MONTGOMERY COUNTY HISTORIC PRESERVATION COMMISSION
STAFF REPORT

Address:	5800 Connecticut Avenue, Chevy Chase	Meeting Date:	9/4/2024
Resource:	Non-Contributing Resource (Chevy Chase Village Historic District)	Report Date:	8/28/2024
Applicant:	George Pearce IV	Public Notice:	8/21/2024
Review:	HAWP	Tax Credit:	No
Permit Number:	1082040	Staff:	Chris Berger
PROPOSAL:	Fencing installation.

Figure 5: The applicant provided this site plan to show the proposed fence location, highlighted in orange. Unlike the existing fence, the replacement fence will be located within the property boundaries.

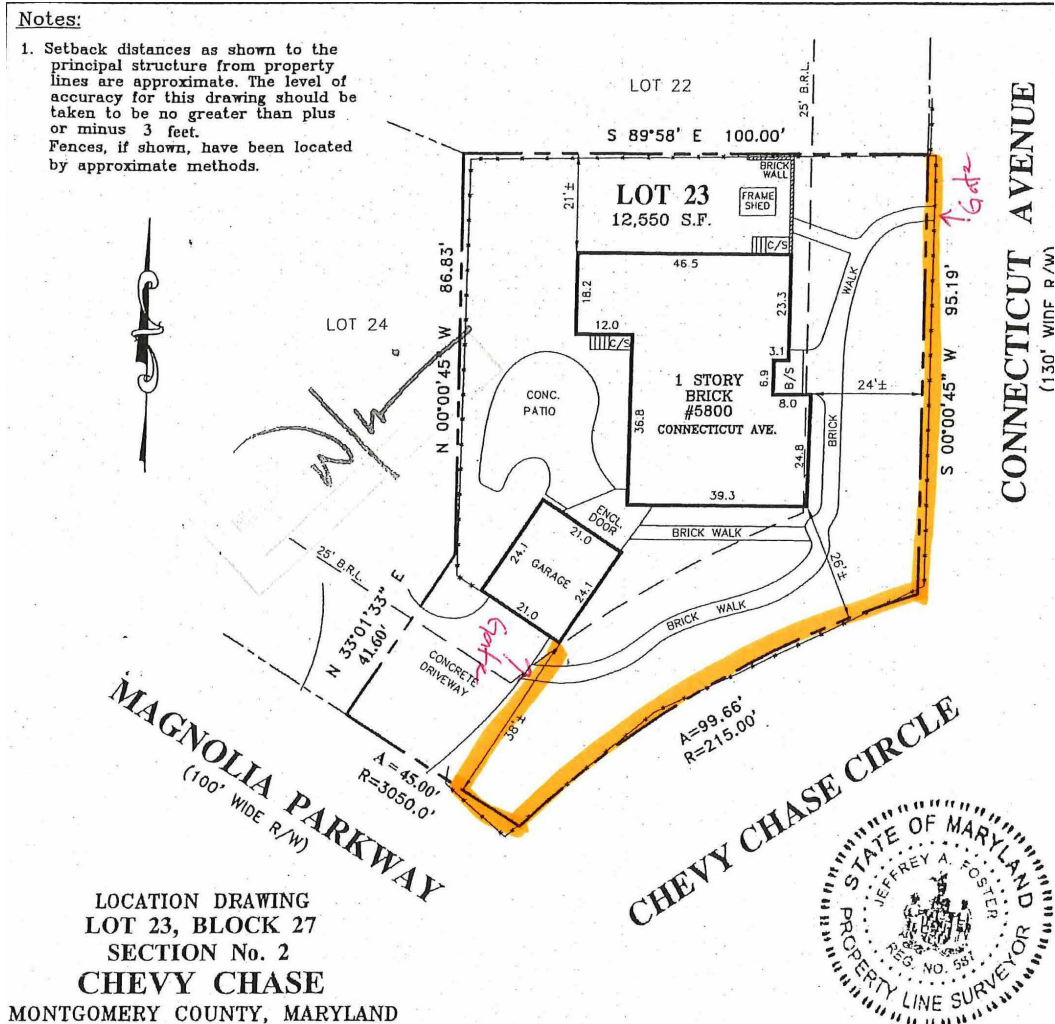
The *Guidelines* state that fences should be subject to strict scrutiny if they detract significantly from the existing open streetscape. Staff does not find that to be the case with the subject property, where the fence will be set back approximately 30 feet from both Connecticut Avenue and Magnolia Parkway. It will be approximately 20 feet from Chevy Chase Circle at its closest point, but most of the fence will be at least 30 feet away from the edge of the Circle, so the visual impact of the taller and solid fence will be minimal. The *Guidelines* continue that fences should be subject to moderate scrutiny if they are visible from the public right of way. Staff finds the fence meets the moderate scrutiny because the fence is of a compatible material and preserves the integrity of the Non-Contributing Resource.

Further, staff finds the request meets Chapter 24A-8(b)(1), because the proposed fence will not substantially alter either the exterior features of the historic resource or the parklike setting of the historic district. As noted, the fence will be set back from the right of way, limiting its visibility. Further, the 1-foot tall lattice on top will limit the fence's visual impact.

No plans or representative photos have been provided for the two gates to be installed, so staff recommends a condition that the applicant provide that information. Staff seeks another condition that the finished side of the fence must face the right of way, and the structure will face interior toward the residence. Staff is confident this requirement will limit the visual impact of the taller fence.

1. The applicant must provide plans or a representative photo of the two proposed gates.
2. The finished side of the fence must face the right of way.

Figure 6: The fence at 9 Chevy Chase Circle, across Connecticut Avenue from the subject property, has an approximately 4-foot tall stone base with 2 foot tall topper. Source: Google

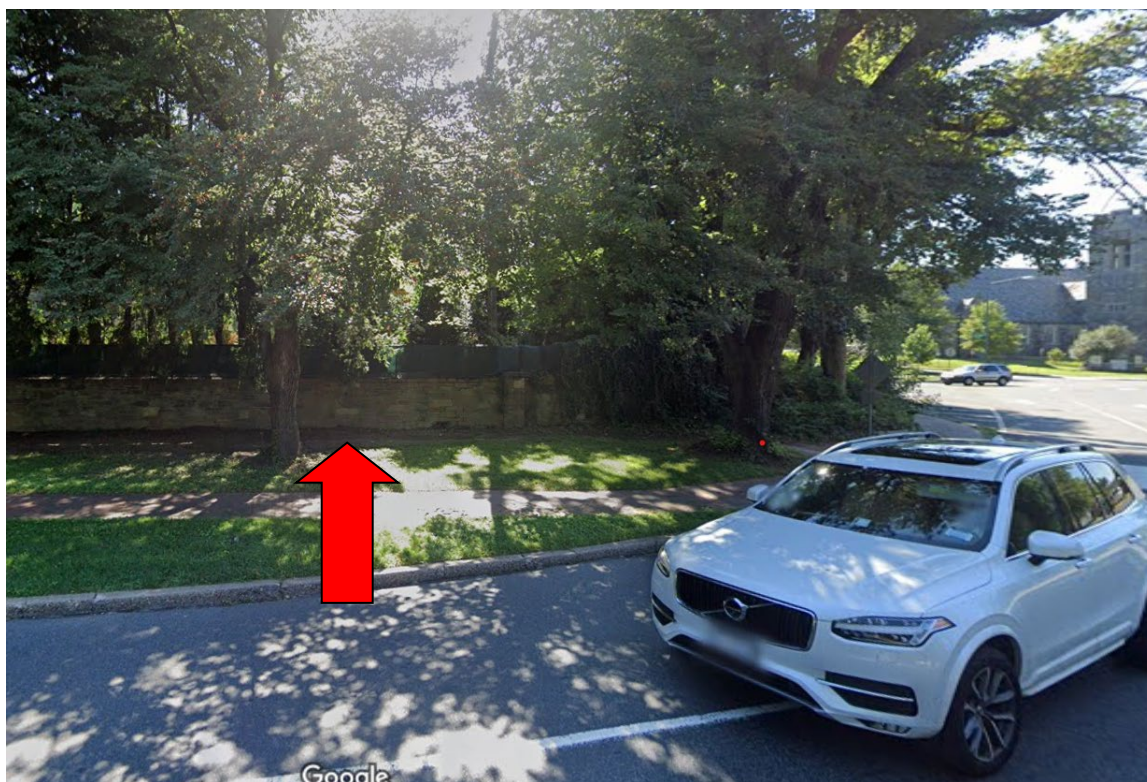
The fence also meets Chapter 24A-8(b)(2), because it is compatible in character and nature with the architectural features of the historic district. Connecticut Avenue and Chevy Chase Circle each have three lanes and are well traversed thoroughfares, and other historic properties within the Chevy Chase Historic District have installed barriers to limit the impact of traffic on their properties. For example, the Newlands-Corby Mansion across the Connecticut Avenue from the subject property at 9 Chevy Chase Circle is both Contributing Resource to the district and a Master Plan Historic Site. It has an approximately 4-foot stone wall with what appears to be a 2-foot tall metal topper that is wrapped and has been present for at least 15 years (*Figure 6*).
